NOTICE OF VIOLATION

INSPECTION REPORT

Electrical Corporation:	Pacific Gas and Electric Company
Report Number:	CAD_PGE_RMA_20241009_1010
Inspector:	Romeo Marroquin Ajcac
WMP Year Inspected:	2024
Quarterly Data Report (QDR) Referenced:	Quarter 2 (Q2)
Inspection Selection:	Energy Safety viewed the contents of the Q2 QDR and performed an analysis that resulted in the selection of the WMP initiatives and locations referenced in this report.
Relevant WMP Initiative(s):	Non-Exempt Expulsion Fuses (2023 WMP initiative number 8.1.2.10.5)
Date of inspection:	October 9, 2024
City and/or County of Inspection:	Oakland, Alameda County
Inspection Purpose:	Assess the accuracy of Pacific Gas and Electric’s QDR data, completeness of its work, compliance with WMP requirements, and compliance with its protocols.

Item1IA1mg1: Overall area

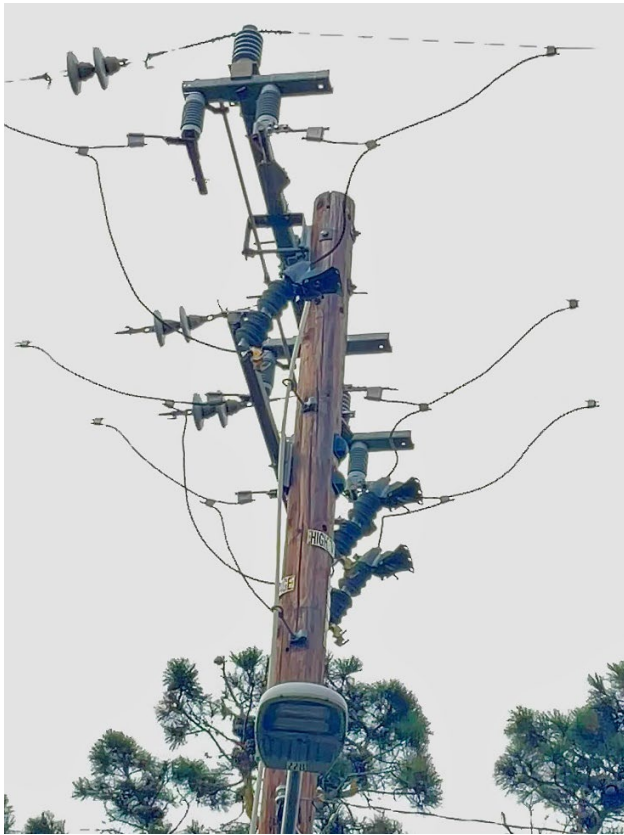
On pole ID 110517663, Grid Hardening ID 31661651, at 4101 Mountain View Ave, Oakland, CA, 94605, USA, 37.782354, -122.174886, the inspector observed that no fuses were installed in the cutouts. The inspector's observation is documented in Violation 1 photographs, which are attachments to this report. Photo numbers Item1IA1Img1, Item1IA1Img2, Item1IA1Img3, and Item1IA1Img4 depict non-exempt expulsion fuses.

1. Pacific Gas and Electric Company reported that WMP initiative 8.1.2.10.5 – Non-Exempt Expulsion Fuses was completed at this location.
2. No fuses were observed at this location.
3. Non-exempt expulsion fuses (8.1.2.10.5) were not replaced with CALFIRE-exempt expulsion fuses.
